Louisiana Energy Services, L. P.  
National Enrichment Facility  
NRC Docket No. 70-3103

**Subject:** Response to NRC Request for Additional Information Regarding National Enrichment Facility Safety Analysis Report and Emergency Plan

Louisiana Energy Services  
Response to April 19, 2004  
Request for Additional Information

**Figure ISA-9.1**

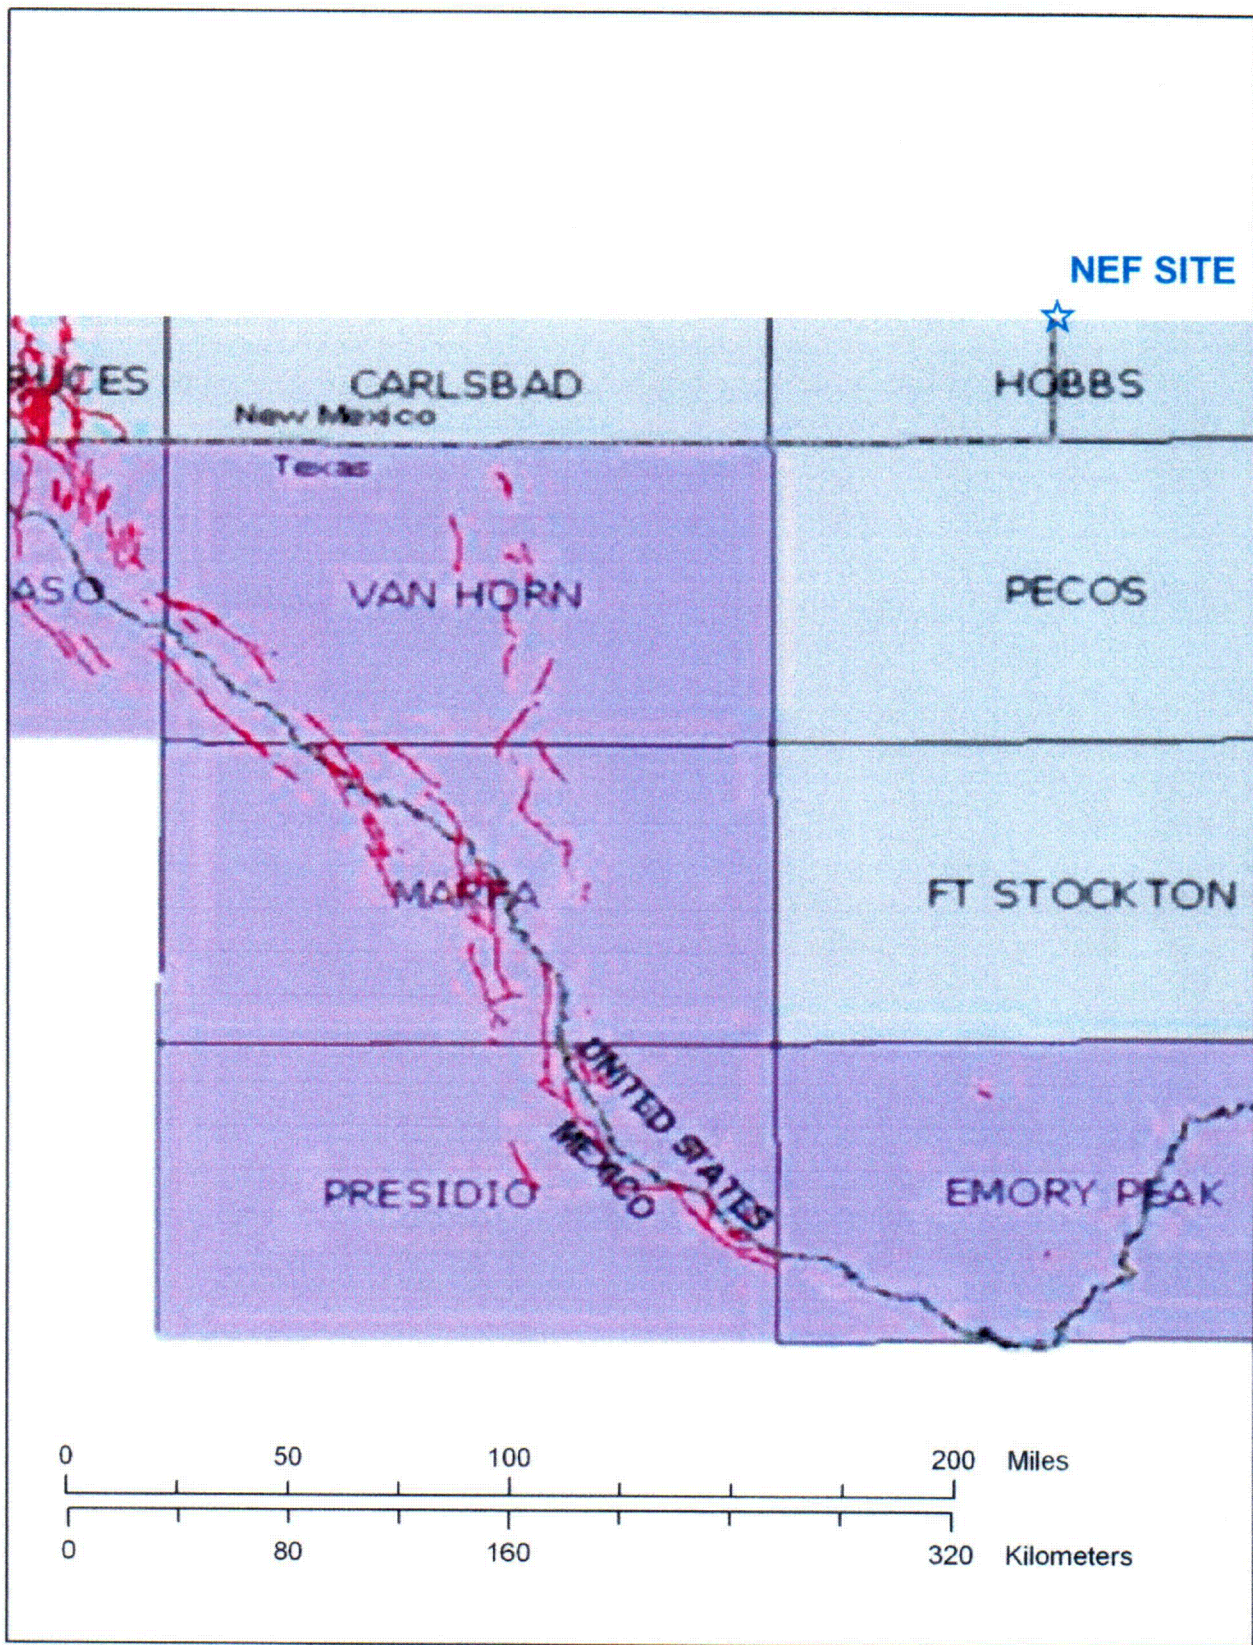
Provide results of investigations conducted to identify any capable faults within a 322-km [200-mi] radius. Page 3.2-23 of the Safety Analysis Report states, "No Quaternary faults are mapped for the site locale. The nearest recent faulting is situated more than 161 km [100 mi] west of the site." It is not clear if any of these faults are capable.

(Note: Figures ISA-9.1 through ISA-9.4 are provided in Attachment 3.) Figure ISA-9.1, Quaternary Faults in New Mexico, and Figure ISA-9.2, Quaternary Faults in Texas, illustrate traces of Quaternary Faults for New Mexico and adjacent areas of west Texas. The Quaternary geologic time period extends from 1.6 million years ago to the present. Other time sub-divisions within the Quaternary include the Late Quaternary that extends from 130,000 years ago to the present, and the Holocene, which includes the most recent 10,000-year time period.

Shown on Figures ISA-9.1 and ISA-9.2 are 1° Latitude by 2° Longitude geographic blocks. The NEF site is located in the Hobbs geographic block. Geographic blocks containing Quaternary faults are color-coded (i.e., non-gray). Figure ISA-9.3, Quaternary Faults Within 322 km (200 mi) of NEF Site, shows geographic blocks for which Quaternary faults are mapped. All of these geographic blocks are located west of the NEF site. Figure ISA-9.4, Locations of Nearest Faults to the NEF Site, shows the Quaternary fault locations detailed in the “Map and data for Quaternary faults and folds in New Mexico, U.S. Geological Survey (USGS) Open-File Report 98-521.” The block containing the site, as well as others due north, south, and east of the NEF site has no documented Quaternary faults. Quaternary faults within 322 km (200 mi) of the site are shown on Figure ISA-9.3 using colored and numbered traces, and are plotted over shaded relief topographic maps. The use of topographic relief maps is highly illustrative, because ground deformations resulting from recent fault movements are usually manifested as prominent linear topographic features.
